Groundwater Transfer Review Summary Form

Transfer/PA # T- 14660

Application: T-14660 Applicant Name: Antelope Springs Hay Farm LLC/Golden Rule Farms

Proposed Changes: ☒ POA ☐ APOA ☐ SW→GW ☐ RA
☐ USE ☒ POU ☐ OTHER

Application T-14660 (T27S-R17E, Sections 16 & 27)

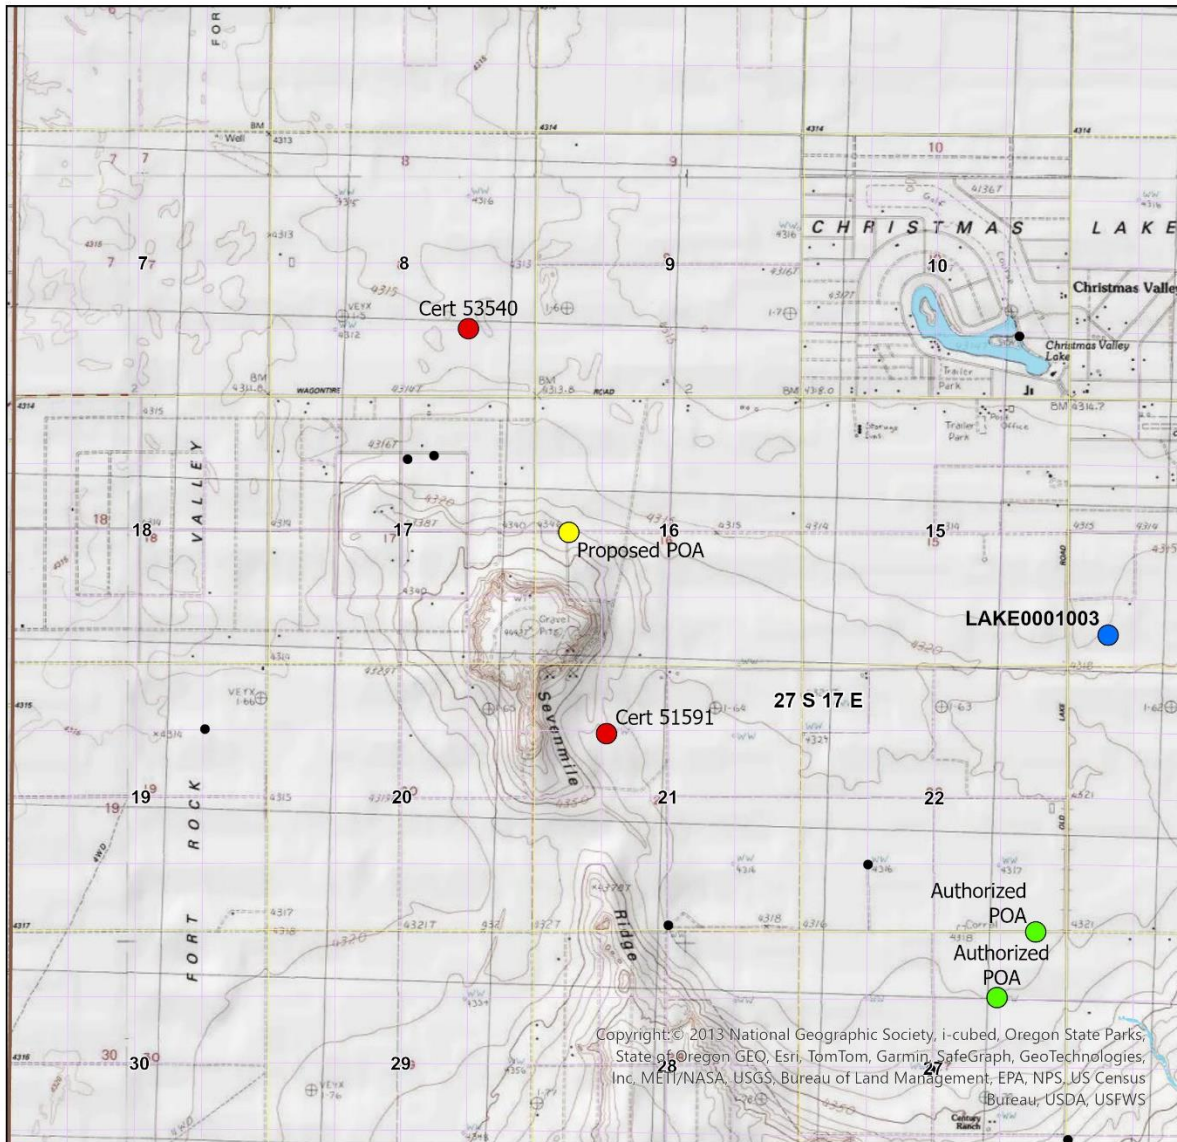
- LAKE 1003 (attached) is a nearby well (11,300 ft SE of LAKE 1016) with an excellent hydrographic record and a similar depth to LAKE 1016. The main difference being that LAKE 1003 encounters basalt while LAKE 1016 may be completed in basin fill sediments/sedimentary rock. LAKE 1003 seems to be a good observation well to show the cumulative drawdown of nearby irrigation wells. Feb – Aug 2024 measurements show a drawdown of 7.24 ft. It seems that this area recovers well from seasonal drawdown as a comparison of spring measurements from 2004 to 2024 indicates 2.03 ft decline.

☒ Yes ☐ No Comments: The nearest SW source likely to be affected is Paulina Marsh. The proposed POA is moving use 1 mile closer to Paulina Marsh. The closest authorized POA is 14 miles away, while the proposed POA is 13 miles away.

Estimation of Drawdown effects
on LAKE 1031

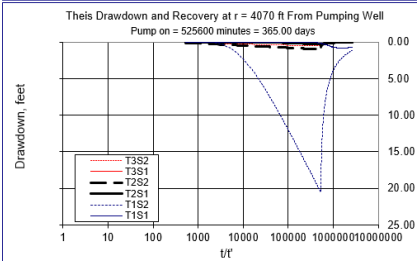
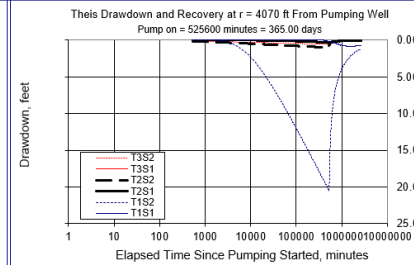
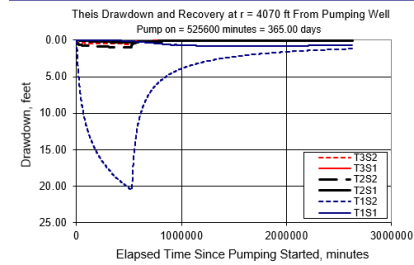
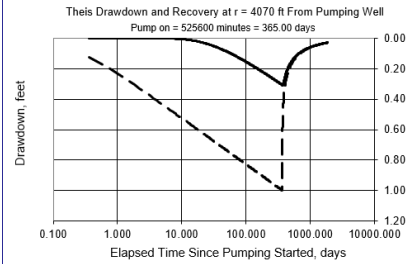
5. a) Will this proposed change, at its maximum allowed rate of use, likely result in an increase in interference with **another ground water right**?
☒ Yes ☐ No Comments: The nearest GW POA to the proposed POA LAKE 1016 is LAKE 1031 authorized under Certificate 51591 at a distance of 4070 ft. The addition of 12.4 acres to this pivot and the corresponding water demand will likely increase interference with nearby wells.

- b) If yes, would this proposed change, at its maximum allowed rate of use, likely result in another groundwater right not receiving the water to which it is legally entitled?
☐ Yes ☒ No If yes, explain: Using the most conservative aquifer parameters and assuming year-round use along with max rate, peak drawdown could increase by nearly 4.3 ft in LAKE 1031. This estimation represents a low transmissivity and storage coefficient for the area, which is unlikely due to the well information provided in this application in addition to the groundwater trends of a nearby observation well. All other estimates show that peak drawdown would increase from 0.07 – 0.21 ft. Additionally, LAKE 1031 is a deeper well drilled to 500 ft and considering the SWLs in the immediate area are around 25-40 ft BLS, there should be a minimal impact on this POA from the increase in interference.

Drawdown S on LAKE 1031	T1S1	T1S2	T2S1	T2S2	T3S1	T3S2
Pre T14660	0.65	16.25	0.24	0.79	0.16	0.43
Post T14660	0.82	20.52	0.31	1	0.2	0.54
Difference	-0.17	-4.27	-0.07	-0.21	-0.04	-0.11
